ADDENDUM IDAP REPORT

Property:	98 Redmyre Road STRATHFIELD Lot: A DP: 311262 DA2019/148/2 S4.55(2) Modification Application involving internal and external reconfiguration of windows, external appearance and ancillary structures.
Proposal:	
Applicant:	Princeton Piper Pty Ltd
Owner:	Robyn Tartak
Date of lodgement:	10 September 2020
Date of IDAP Meeting:	18 December 2020
Notification period:	18 September - 03 October 2020
Submissions received:	One (1)
Assessment officer:	E Black
Estimated cost of works:	\$2,770,350.00
Zoning:	R2-Low Density Residential - SLEP 2012
Heritage:	Yes – site within C14 - Redmyre Rd Heritage Conservation Area
Flood affected:	No
Is a Clause 4.6 Variation Proposed:	No N/A
RECOMMENDATION OF OFFICER:	APPROVAL

IDAP REPORT – SECTION 4.55 (2) MODIFICATION

1 BASEMENT FFL S4.55
1:200

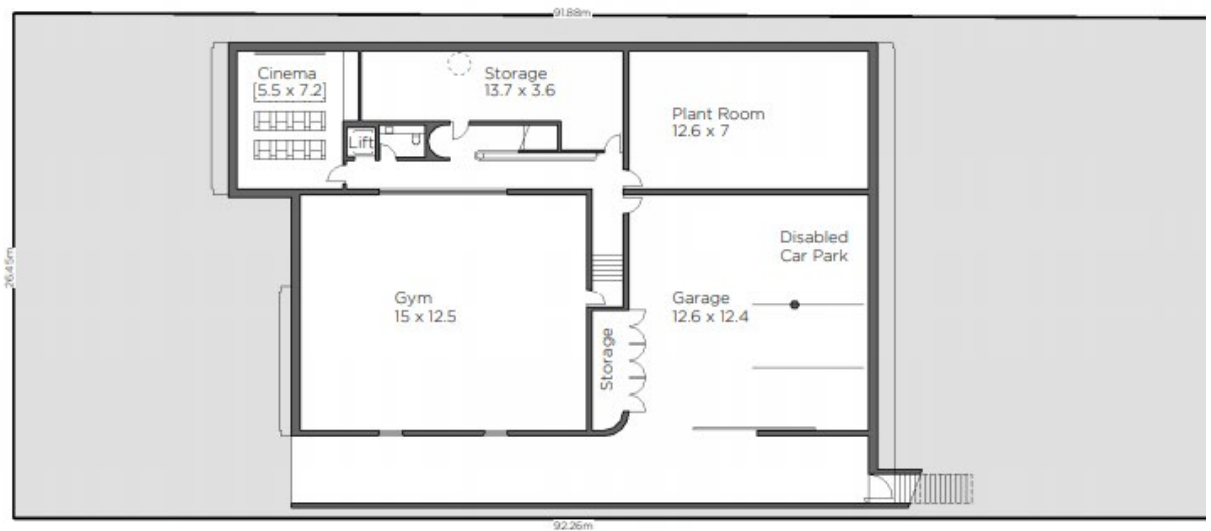
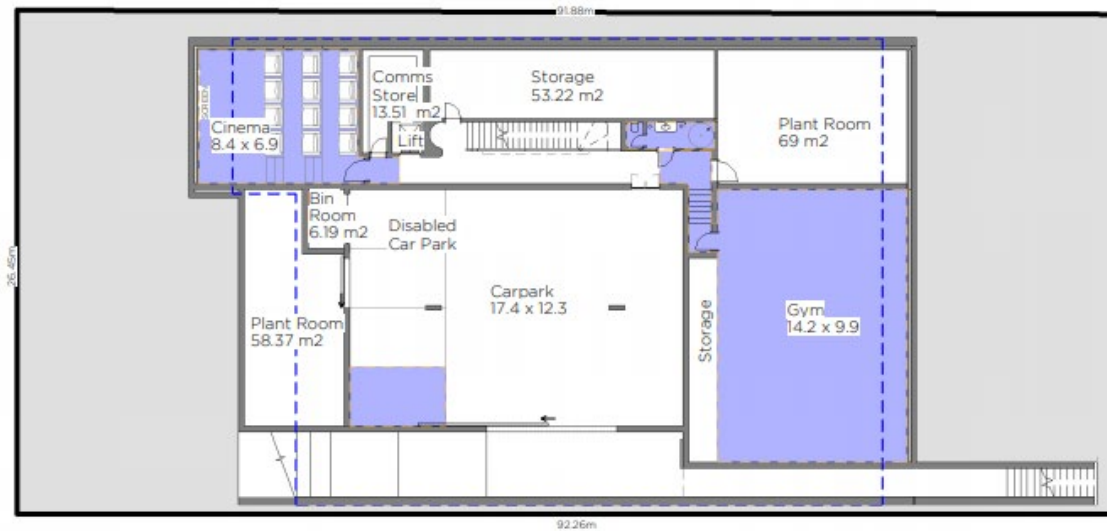
Issue raised by IDAP	Applicants Response	Comment																
Miscalculation of Gross Floor Area (GFA) within the basement level.																		
<p>The new basement is way too excessive and some of the areas should be counted as GFA and towards FSR.</p> <p>Areas of concerns include;</p> <ul style="list-style-type: none">- You cannot justify 2 plans rooms with a total area of approx. 130sqm, when there is also a bin room, Comms room and a number of storage areas/rooms.	<p>The Applicant has submitted GFA basement calculation plans (see Image 2 and 3). The calculations are as follows:</p>

<p>The Applicant has submitted new Spatial Plan of the basement which shows the services housed in the plant rooms was provided.</p>		Mod	Approved - Da	Difference	STORAGE m²	53.22	49	4.22m2	PLANT ROOM m²	127.37	90.72	36.65	TOTAL GFA	234.67	281	-46.33	<p>The GFA shows a reduced basement GFA between the approved and modified plans.</p> <p>The spatial plan shows one of the plant room space will be used to house 2 large rain water tanks with a reuse filtration package. The use of this space (69m2) appears acceptable.</p> <p>The 58.37m2 space will house 1000 litre hot water storage tank, 500litre cold water storage for heating and cooling. The use of this space appears acceptable.</p>
	Mod	Approved - Da	Difference															
STORAGE m²	53.22	49	4.22m2															
PLANT ROOM m²	127.37	90.72	36.65															
TOTAL GFA	234.67	281	-46.33															
<p>A storage room of 54sqm is excessive and should not be excluded. An acceptable exclusion for storage should be around 20 sqm.</p>	<p>An amendment has been made to the basement plan which removes the storage in the carparking area.</p>	<p>The applicant already had 49m2 approved as an exclusion for storage which is more than the 20sqm requested by IDAP. The modification includes a minor increase of 4.22m2 of storage space.</p>																
<p>The area marked as storage within the GYM cannot be excluded, this is not storage room and is part of the habitable GYM room.</p>	<p>No amendment – the storage in the gym is not excluded.</p>	<p>The applicant has included calculations which show that the approved storage was 49m2 which included two storage areas.</p>																
<p>Parking within the basement that is required under the DCP controls is the only parking to be excluded. SCDP only requires 2 spaces whilst the application has 4. There is no requirement to have a disabled parking space and then a shared zone. This is effectively four spaces. Two spaces and the access to and from these should count in GFA.</p>	<p>The applicant has counted an additional carparking space in the GFA calculations but not the access to this space.</p>	<p>Three carparking spaces were not originally counted in the GFA on the plans for the approved Development Application.</p> <p>Therefore, it is acceptable to only include the additional parking space within the GFA over what has already been approved.</p>

the storage cupboard in the garage turning area is to be counted in GFA	An amendment has been made to the basement plan which removes the storage in the carparking area.	The approved plans did not include the storage in the carpark as part of the GFA. The applicant has now removed this storage space. This will also allow for better manoeuvring of vehicles (see Image 4). This is acceptable.
In the comments under the DCP table, how is a 1600mm change in floor to ceiling height minor or acceptable? Is this a typo? Should it read 160mm ??	The DCP table should read 160mm instead of 1600mm.	The typographical error of 1600mm in the IDAP report should read 160mm.
There is the introduction of a side facing terrace/balcony on the eastern side elevation, yet no discussion of this in the report and not correctly shown on the side elevation. Side facing balconies are not allowed under the DCP.	There is no introduction of a side facing balcony/terrace on the eastern side elevation. This was approved as part of the original application. However, the modification has now decreased the size of this balcony/terrace (See Image 6).	No new balcony on the eastern side. Please see Image 6 below which shows the outline of the approved and modified footprint. Please also see Image 10 of the attached IDAP report which shows the approved first floor east facing terrace/balcony.

TOTAL STORAGE: 53.22m2
TOTAL PLANT ROOM: 127.37m2

TOTAL STORAGE: 49m2
TOTAL PLANT ROOM: 90.72m2

3 BASEMENT FFL S4.55 DATA
1:200

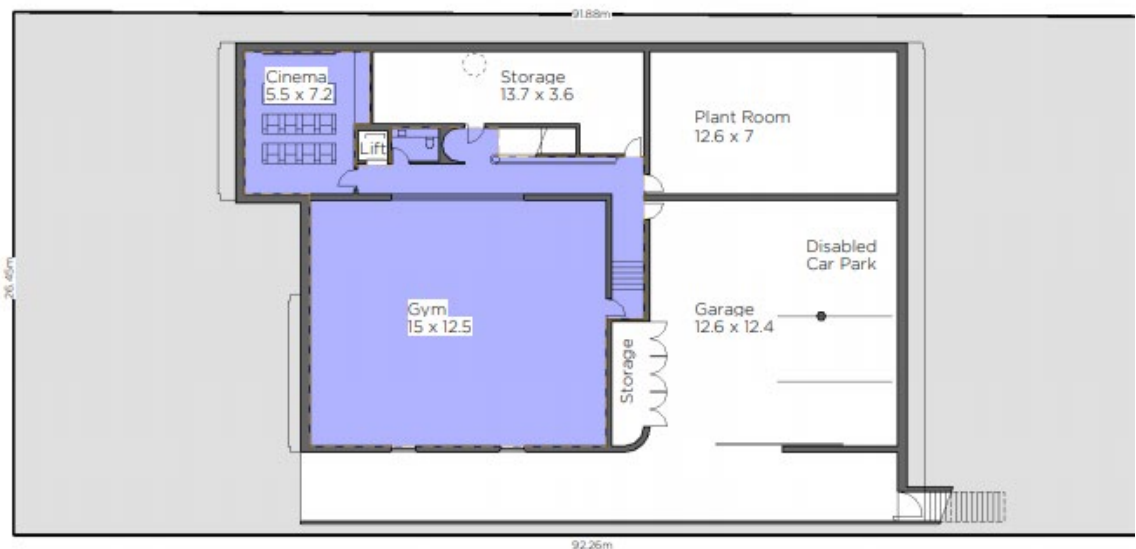
TOTAL GFA: 234.67m²

TOTAL GFA: 281m²

Image 3: Calculation of Gross Floor Area and Building footprint between the approved and modified plans. The previous plan footprint is illustrated with a BLUE DASHED LINE.

Image 6: Plans demonstrating minor increase in footprint between the approved and modified plans.

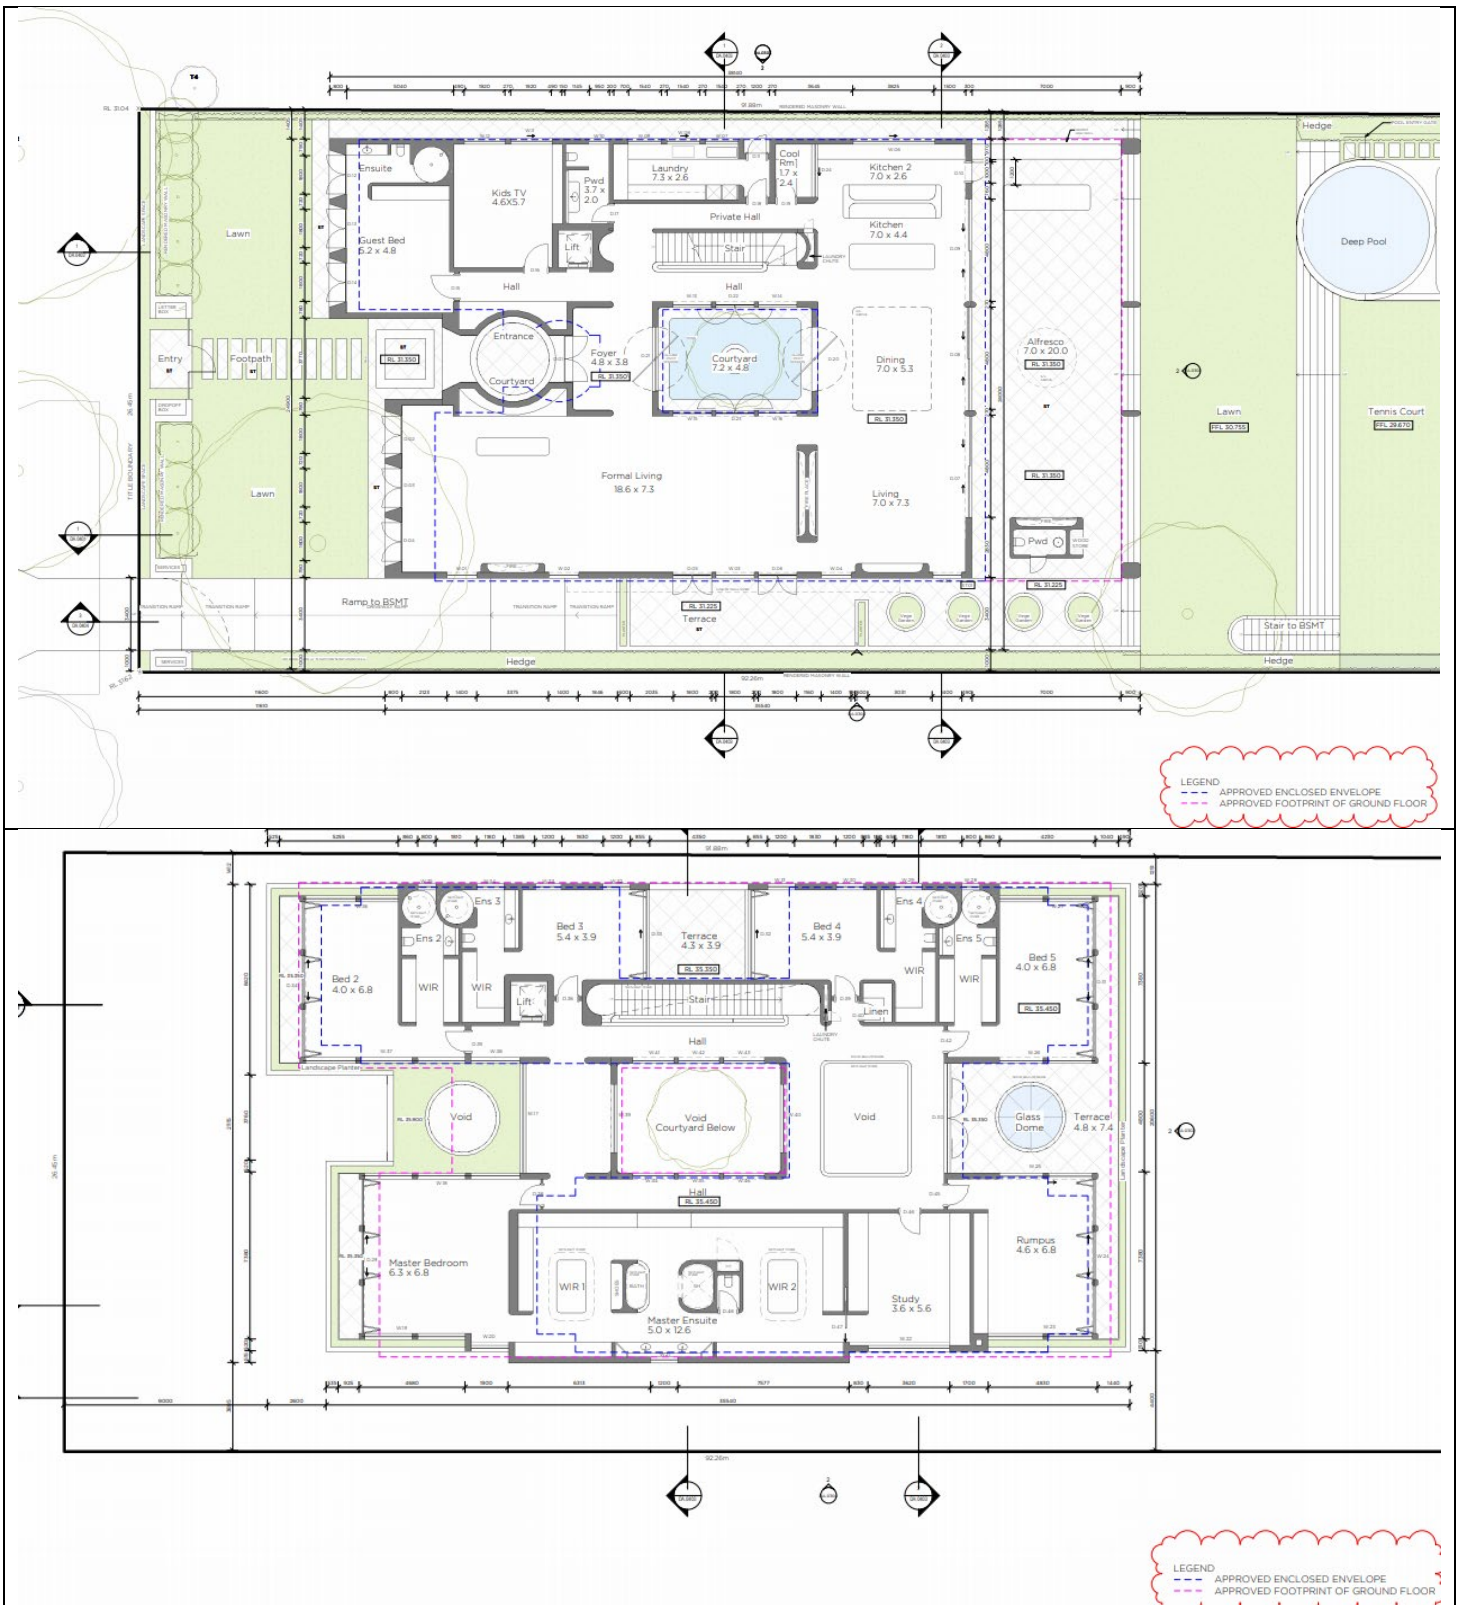
Further to this, the applicant has submitted plans showing that there is a minor increase in the footprint (between the approved and modified plans). It was also demonstrated that the increase was to allow for internal voids to access natural light into the building. Without the voids the dwelling would have limited solar access.

The applicant has submitted further calculations and plans which show the difference between the footprint and floorspace between the modified and approved plans is minor.

Image 3: Modification front fence

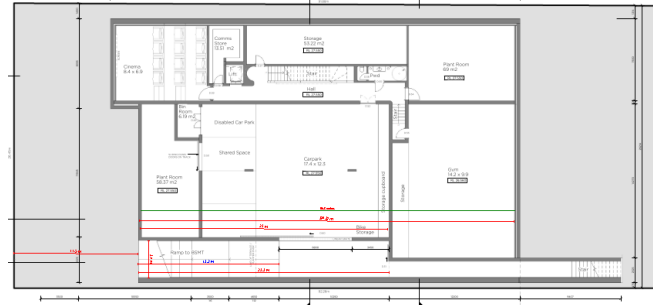
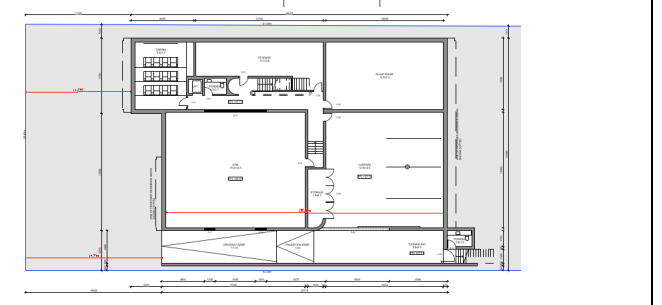
There is also a modification to the fence (see Image 3 and 4). The new fence will be located along the front boundary whilst the previous was located a metre behind the front boundary. There are minimal design changes to the panel and the height will be the same as the existing. It is therefore unlikely to have an environmental impact on the streetscape.

Image 5: Modification Basement – September 2020

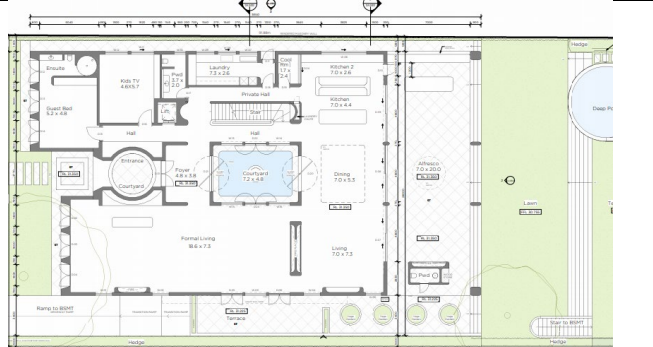
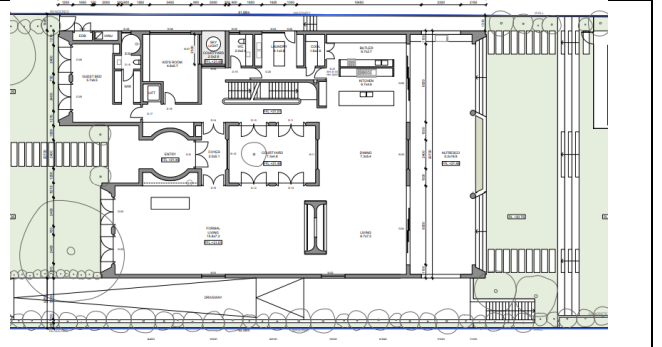
- **Excessive Floor Space Ratio (basement)** – The new plans extends the basement but reduces the Floor Space Ratio. The applicant provided further information on how the additional space is required for the mechanical plant equipment such as, pumps for disposal of rainwater, ventilation, hot water storage, heat pumps and the rainwater tanks.
